Natural Features Protection Review Board

1. 1400 Harrison Street - New Wastewater Treatment Facility

It is recommended the Natural Features Protection (NFP) Review Board approve the NFP Site Plan application for 1400 Harrison Street conditioned upon:

The goal of the project is to construct a new Plastics Removal Facility for the Wastewater Treatment Plant.

KALAMAZOO MILL
 PLASTICS REMOVAL BUILDING
 OVERALL SESC PLAN

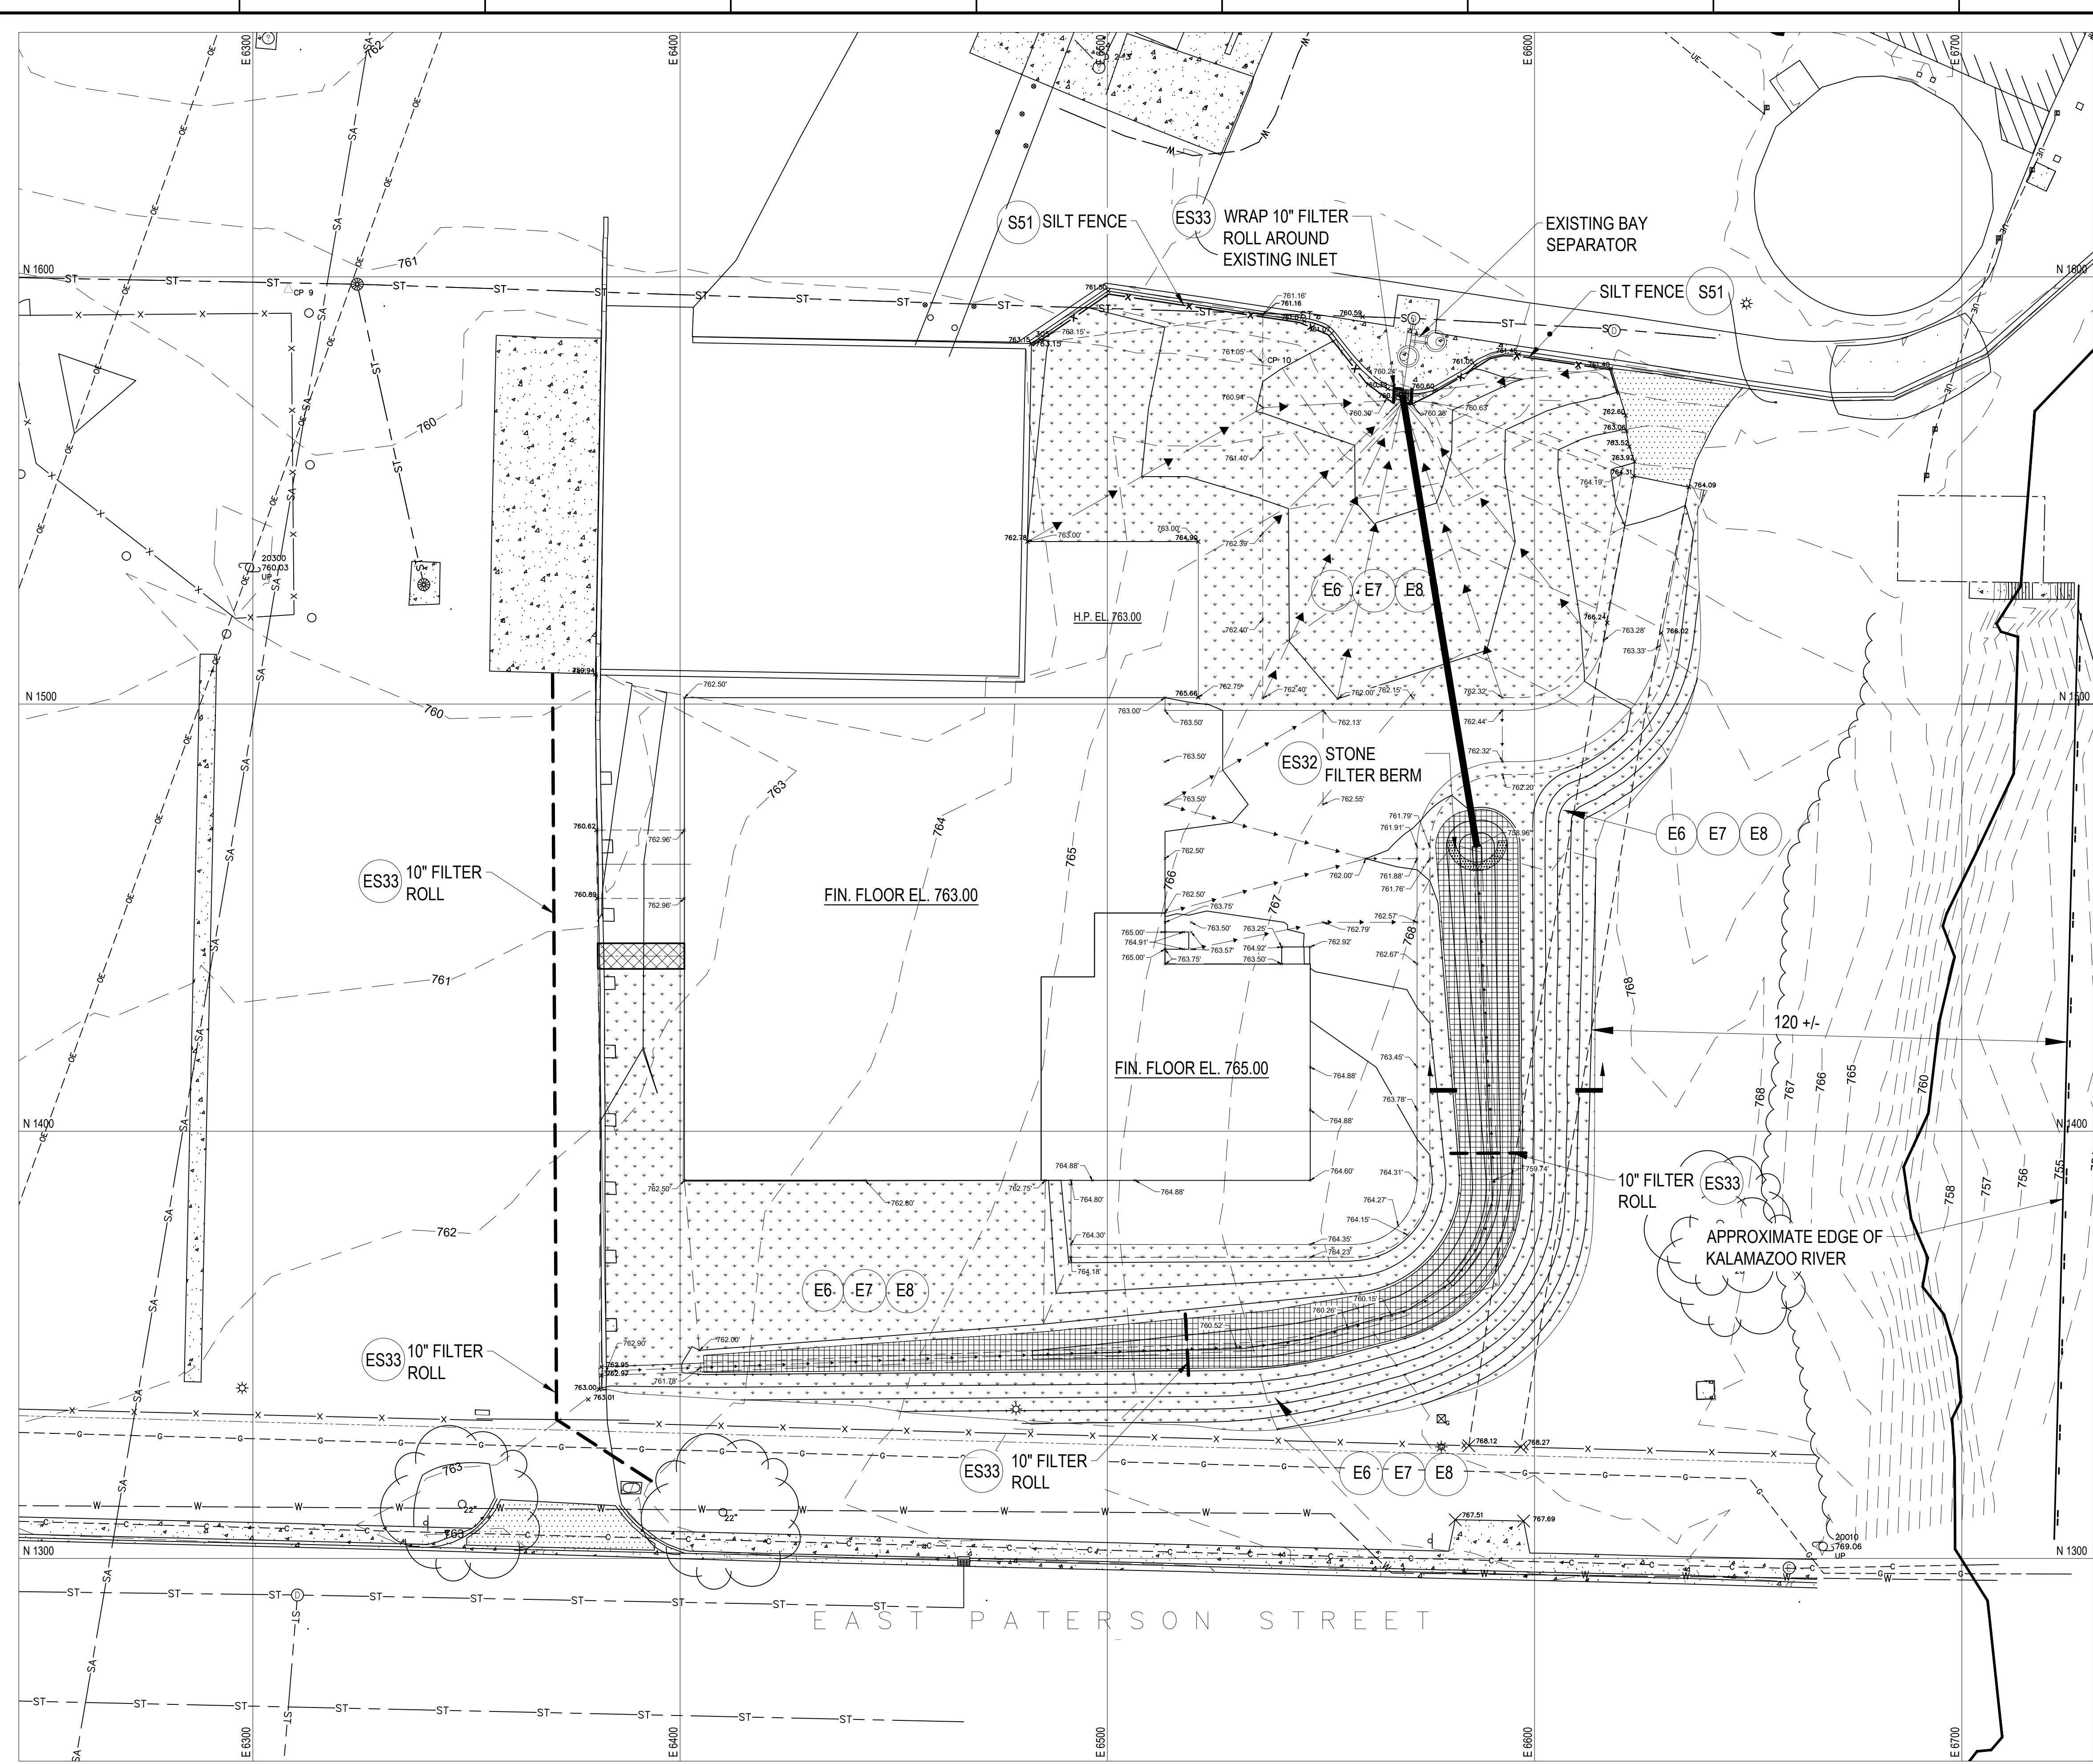
- Approval from the City Stormwater Engineer
- Addition of Tree Protection Fencing for the tree stands adjacent to the Kalamazoo River be included on the SESC plans.
- Full Site Plan Approval
